APPEAL SUMMARY

Appeal ID: 20541	Project Address: 2124 NW Flanders St
Hearing Date: 6/19/19	Appellant Name: Anne Marie Kuban
Case No.: B-012	Appellant Phone: 5032359400
Appeal Type: Building	Plans Examiner/Inspector: Guy Altman
Project Type: lur	Stories: 4 Occupancy: R-2, S, B Construction Type: V-A
Building/Business Name: 2124 NW Flanders	Fire Sprinklers: Yes - Fully Sprinklered
Appeal Involves: Reconsideration of appeal	LUR or Permit Application No.:
Plan Submitted Option: pdf [File 1]	Proposed use: R2-Apartments

G0.2

NW FLANDERS
APARTMENTS
2124 NW FLANDERS ST

2 FIRST FLOOR / SITE PLAN
SCALE: 1/8" = 1'-0"

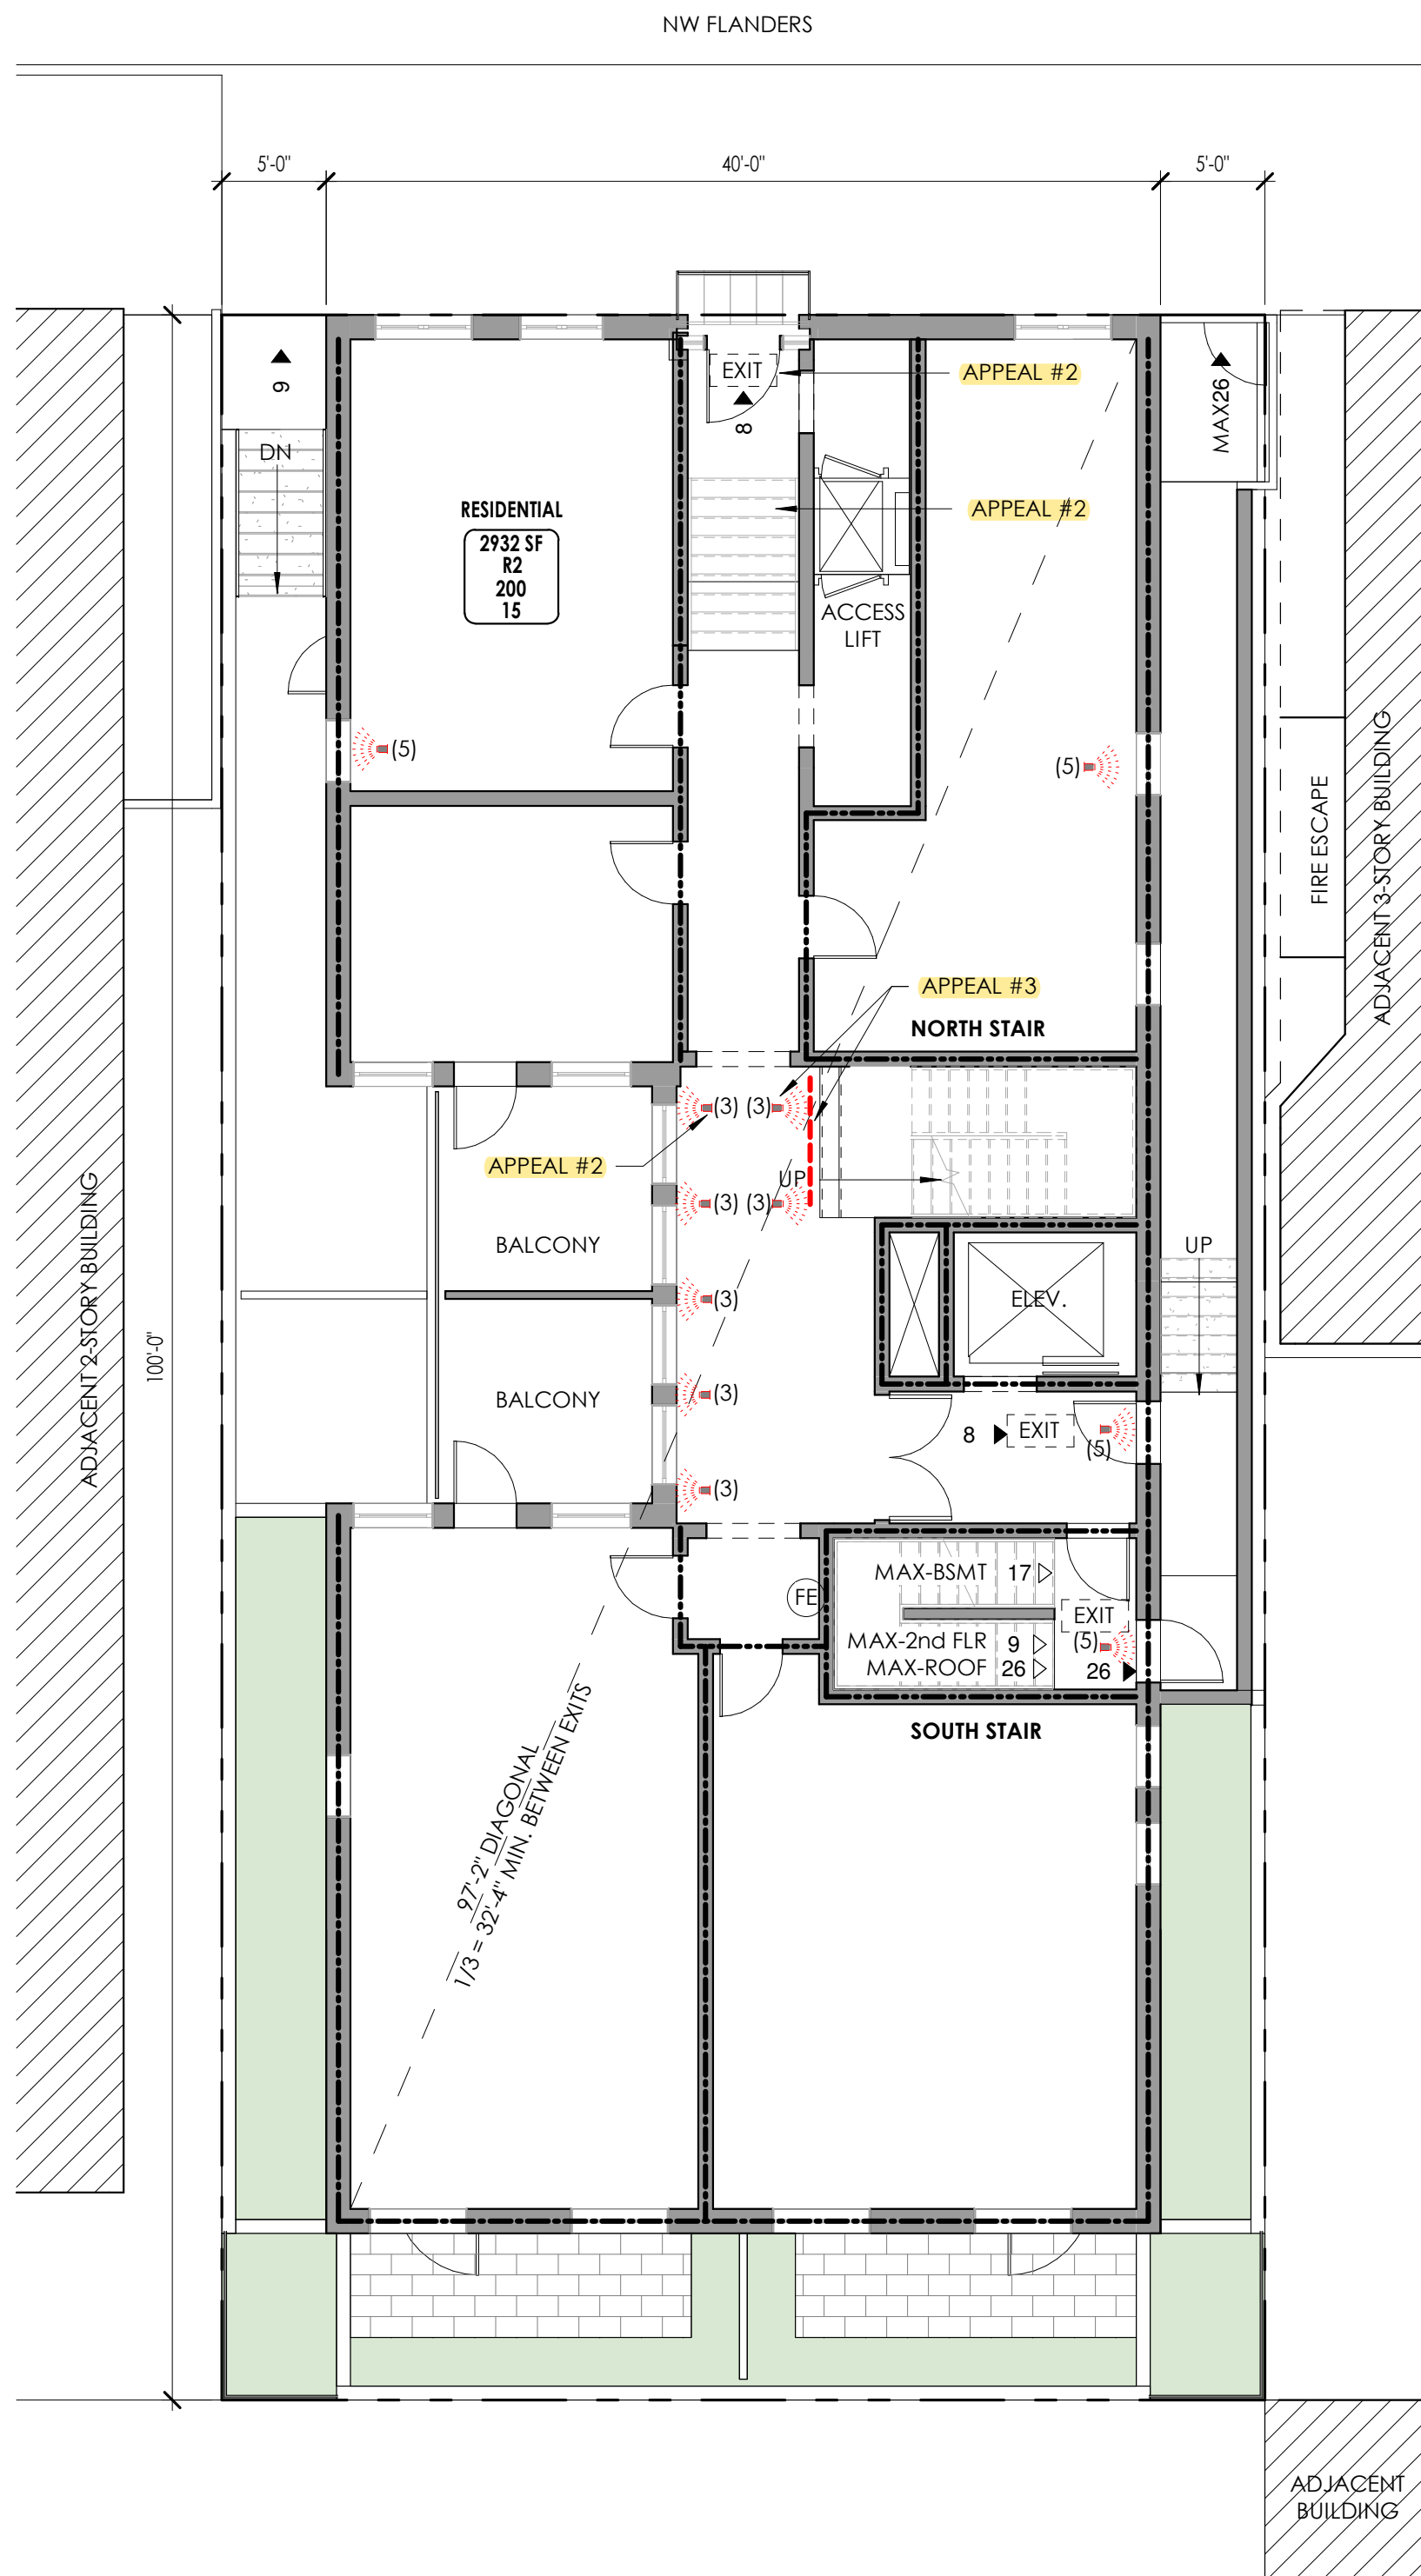
a) Please confirm that we may use the 2012 IBC Commentary page 10-167 to 10-168 allowing our exit discharge lobby to be a lower rating than the interior exit stairway because we will be fully sprinklered AND that we are fire-rating the supporting floor, bearing walls, columns and beam construction below the exit discharge lobby (2HR). Please see 2/G0.2.

b) Please confirm that the North Stair and path to the exit door (with added exit signage) is immediately identifiable/visible to the egressing occupants. Please see 2/G0.2.

c) In our Early Assistance meeting, Guy Altman indicated that the stairs within the exit discharge lobby would be considered an obstruction to the path of travel and did not meet the requirement of 1027.1 Exception 1.1. The stairs in the exit discharge lobby provide direct access to grade for the lobby and are simply an element in the required egress system. Please confirm these stairs are an allowable obstruction in the path of travel to the exterior door.

Response to Items A and B: We are proposing a revised lobby exit discharge strategy with the

understanding that we would like to pursue “open” exit stair at the ground floor only, as described in the Appeal Item #3. The new strategy proposes the following:

2HR enclosure at the exit discharge lobby,

2HR protection from the basement and for supporting members in the basement under the exit discharge lobby,

Draft curtain and closely space sprinklers at the base of the stair as allowed by 1009.3 Exception 4,

Elevator separated by a smoke barrier device at the elevator shaft door PLUS doors on magnetic holdopens at the elevator vestibule, and

Windows at the exit discharge lobby to separate an R2 balcony from the R2 lobby: to have closely spaced sprinklers providing an alternate to the 2HR enclosure.

- a) per 1009.3 Exception 4 the design proposes draft curtain and closely spaced sprinklers at the base of the stair to separate the exit discharge lobby from the stair. Please see 2/G0.2.
- b) at this level, the elevator is also separated by a smoke barrier device at the elevator shaft door PLUS doors on magnetic holdopens at the elevator vestibule. Please see 2/G0.2.
- c) Please refer to Appeal #13275 #4, Case No. B-014 for a similar approval.

We are proposing the same design strategies as noted in the prior Appeal BUT we are revising the exit discharge lobby design—as noted in the RECONSIDERATION TEXT above -- which we understood to be the issue. Please see drawings.

1. Stair discharge into Lobby: Hold for additional information.

2. Open stair discharge into Lobby: Hold for additional information.

3 ROOF PLAN
SCALE: 1/8" = 1'-0"

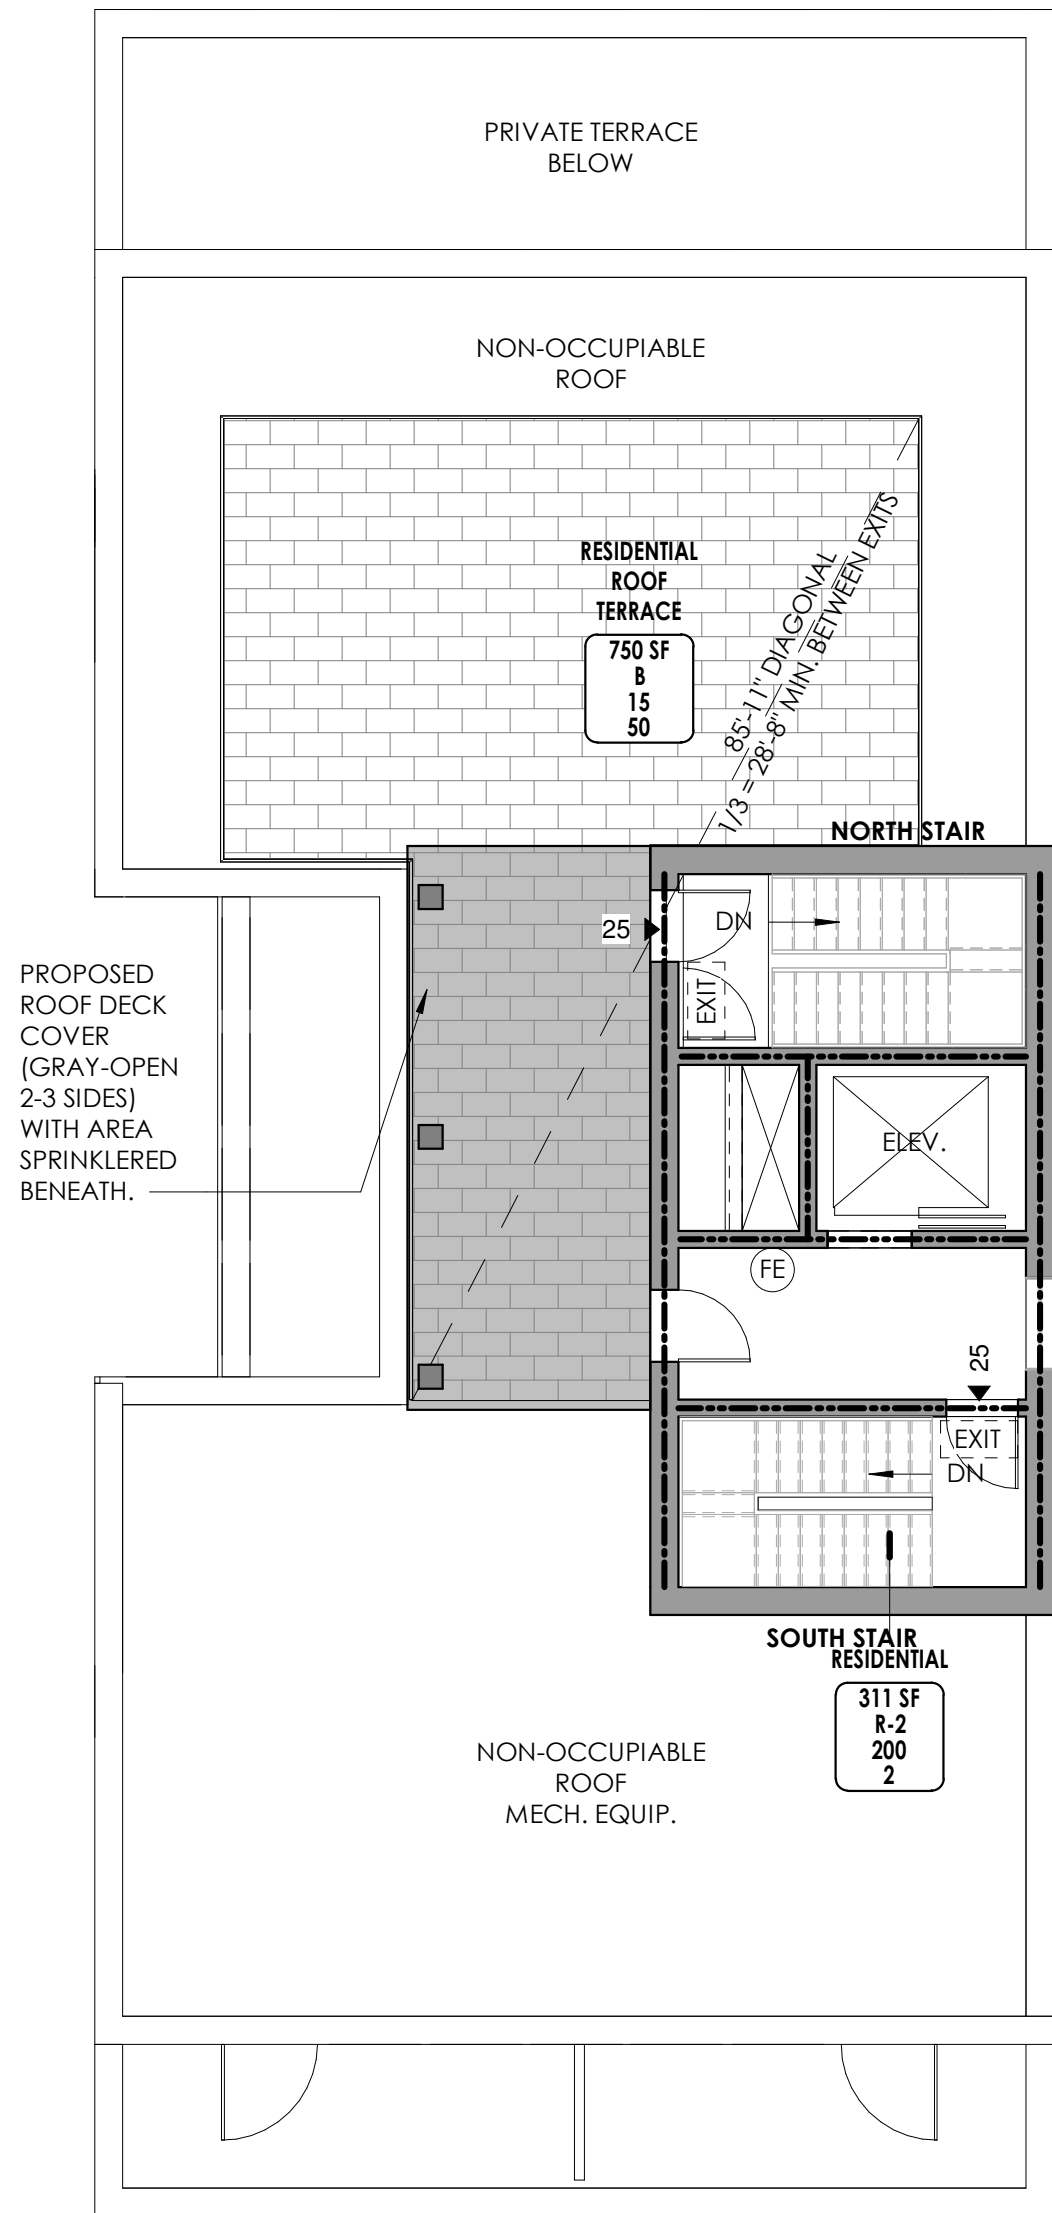
The proposed design includes R2 occupancy on all floor below the roof deck. The residential roof terrace is a proposed B occupancy / 749 SF / 15 Occupant Load Factor / 50 maximum occupants. The proposed building is fully sprinklered and will provide the required fire alarm notification on the roof, egress lighting and signage. Please provide confirmation that the project can use the 2018 IBC requirements for occupied roof decks and it NOT be considered a story. Please see 3/G0.3.

The proposed design is contemplating a covered area of the occupied rood area for rain/sun protection. Please see drawings. This overhead structure would be open on 2-3 sides and the structure would include fire sprinkling per Chapter 9 requirements. Please clarify if this covered portion of the roof deck will be allowed.

In the Granting of Appeal 20302 Item #6, the Board indicates that there is a limit on height of enclosing structures. We would like to verify that a roof deck cover (open 2-3 sides) will be allowed.

3. Covered roof deck located above maximum number of stories: Denied. Proposal does not provide equivalent Life Safety protection.
